**Subject: MHI's Responses to US-APWR DCD RAI No. 320-2010 REVISION 1**

**Reference:** 1) "REQUEST FOR ADDITIONAL INFORMATION NO. 320-2010 REVISION 1, SRP Section: 09.05.07 - Emergency Diesel Engine Lubrication System, Application Section: 9.5.7", dated April, 6, 2009.

**US-APWR Design Certification**

**SRP SECTION:** 09.05.07 - EMERGENCY DIESEL ENGINE LUBRICATION SYSTEM

Figure 9.5.7-1 Gas Turbine Lubrication System Schematic Diagram

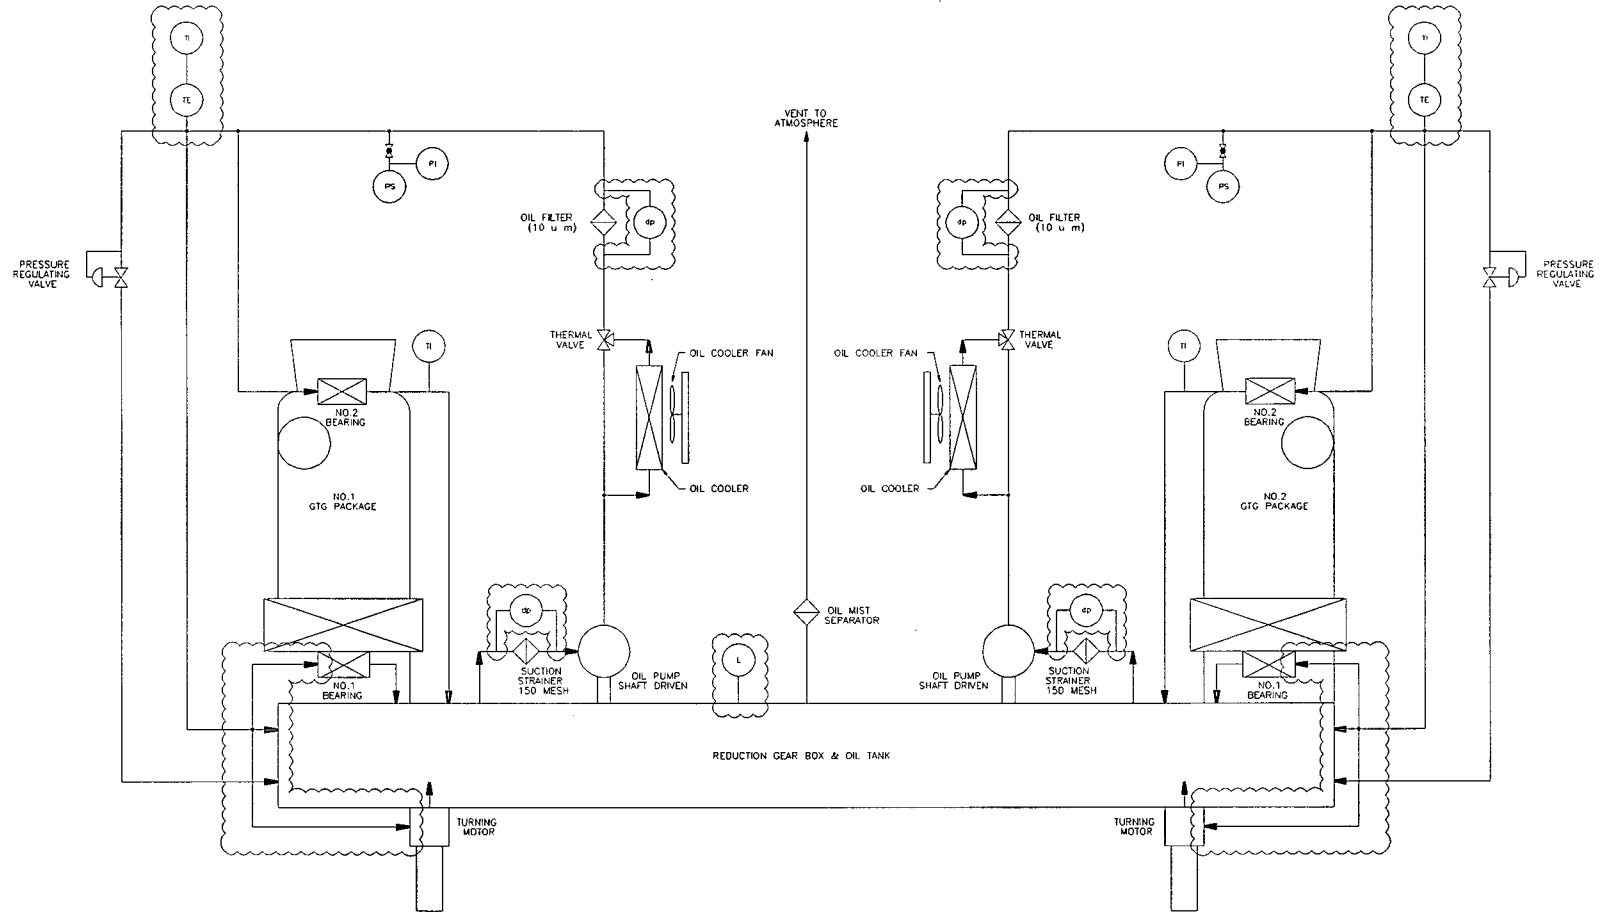
FSAR Tier 2 Figure 9.5.7-1 is inconsistent with the corresponding figure in "Qualification and Test Plan of Class 1E Gas Turbine Generator System," December 2007 (MUAP-07024-P (R0) – Figure B.4.2-1. For example, the oil flow path to the No. 1 bearing is not the same in both drawings. The FSAR figure appears to show the turning motor as the source of oil to this bearing. Compare the figures and revise the FSAR figure to accurately reflect the system flow paths. Regulatory Basis – GDC 17.

According to FSAR Figure 9.5.7-1, there is a local temperature indicator for each No. 2 bearing and no temperature measurement for the No. 1 bearings. To provide system monitoring capability that is commensurate with the importance of the safety functions to be performed and to ensure system reliability, provide a high temperature alarm (alarmed in the main control room) for each of the GTG main bearings. Revise the FSAR to include these features. Regulatory Basis – GDC 17.

Section 9.5.7.5 of the FSAR does not identify any instrumentation or alarms for high differential pressure across filters or strainers (a differential pressure indicator is shown on Figure B.4.2-1 of MUAP-07024-P(R0), but none are shown on FSAR Figure 9.5.7-1 and no remote alarms are shown on either figure). In addition, the method for determining lube oil reservoir level is indicated as a dipstick. To provide system monitoring capability that is commensurate with the importance of the safety functions to be performed and to ensure system reliability, each filter and strainer should be provided with differential pressure instrumentation that alarms in the main control room on high level and the lube oil reservoir level should be monitored by level instrumentation and low levels should be alarmed in the main control room. Revise the FSAR to include these features. Regulatory Basis – GDC 17 and the guidance of SRP Section 9.5.7 guidelines which state that P&IDs include the means for indicating and monitoring oil levels, temperatures, and pressures.

There are temperature and pressure control devices shown in the lubricating oil flow path on FSAR Figure 9.5.7-1 and Figure B.4.2-1 of MUAP-07024-P (R0). The figures show a temperature regulating valve and pressure regulating valve (appears to be shown as a pressure relief valve on Figure B.4.2-1). Provide a description of the control devices included in the GTLS that can impact system function with a discussion of the potential for their failure to cause GTG failure and a discussion of the design requirements included to minimize that potential. Amend the FSAR to include specific design requirements that are important to the reliability of the system. Regulatory Basis - GDC 17

Figure 9.5.7-1 of DCD will be revised based on Figure B.4.2-1 of "Qualification and Test Plan of Class 1E Gas Turbine Generator System," December 2007 (MUAP-07024-P (R0).

Figure 9.5.7-1 of DCD will be revised as shown in Attachment A.

High temperature alarm and trip signal indicate common line temperature of supply piping for No.1 bearing and No.2 bearing. Lubricating oil flow path in Figure 9.5.7-1 will be revised based on Question 09.05.07-4.

Figure 9.5.7-1 will be revised to add instrumentation for high differential pressure across filters or strainers and lube oil reservoir level instrumentation.

Figure 9.5.7-1 will be revised as shown in Attachment A.
